ITEM III-A: DESIGN REVIEW PERMIT & TREE PERMIT – 1001 SECRET RAVINE PARKWAY – AGORA AT STONERIDGE RETAIL CENTER – FILE # PL13-0041

REQUEST

The applicant requests approval of a Design Review Permit to construct a 45,600 square foot retail center with associated site improvements including parking, lighting and landscaping. In addition, the applicant requests approval of a Tree Permit to remove 13 Native Oak Trees.

Figure 2: Site Plan

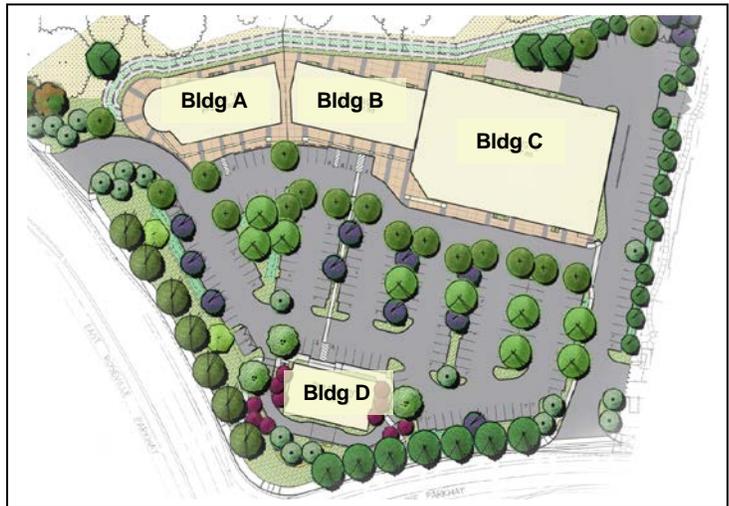
The two nearest buildings to the street (Buildings A and D) will be setback a minimum of 100’ and 40’ from East Roseville Parkway and Secret Ravine Parkway, respectively. Consistent with the Stoneridge Specific Plan Design Guidelines, a 50’ and 25’ landscape buffer is proposed along East Roseville Pkwy and Secret Ravine Pkwy. Based on the size of the buildings, the proposed setbacks will provide a sufficient buffer from the street allowing adequate space for landscaping, parking, and onsite improvements.

Vehicle Access & Circulation: Access to the project site will be provided via two driveways (one on Secret Ravine Pkwy and one on East Roseville Pkwy) that will be restricted to right turns in and out of the development. Based on this design, traffic headed east on East Roseville Pkwy or north on Secret Ravine Pkwy will need to make u turns to enter the site. However, there will be a free right turn lane located on the corner of East Roseville Pkwy and Secret Ravine Pkwy, which will limit the turning conflicts between motorists making u turns on East Roseville Pkwy and traffic turning onto East Roseville Pkwy from Secret Ravine. In addition, reciprocal access agreements are recorded between the project site and the adjacent property to the east, which will further improve the internal circulation pattern and provide an additional access point to and from the site (see Attachment 3). The main entrance on Secret Ravine Pkwy will provide direct access to the drive thru located on the eastern side of Building C and will provide a turn-around area at the end of the aisle, allowing for adequate emergency vehicle circulation. The internal circulation pattern will consist of six two-way drive aisles that run perpendicular to Buildings A-C. In addition, a drive aisle around the perimeter of the site will provide access to Building D's drive thru located adjacent to the intersection. Consistent with the CDG, both drive thrus will provide a one hundred foot stacking distance and have been adequately incorporated into the site design.

Based on the reciprocal access agreements and site layout, which includes a turn-around area, staff does not anticipate any circulation issues. The Fire Department has reviewed the site plan and has no concerns.

Bicycle Parking/Circulation: Per the Zoning Ordinance, a minimum of one bicycle space shall be provided for every twenty required parking spaces. Based on the parking required for the site (208), a minimum of ten bicycle racks are required. The site plan does not identify the provision of bicycle parking; however, Condition #3 of the DRP has been added requiring that ten bicycle parking spaces be provided in convenient and visible locations throughout the center.
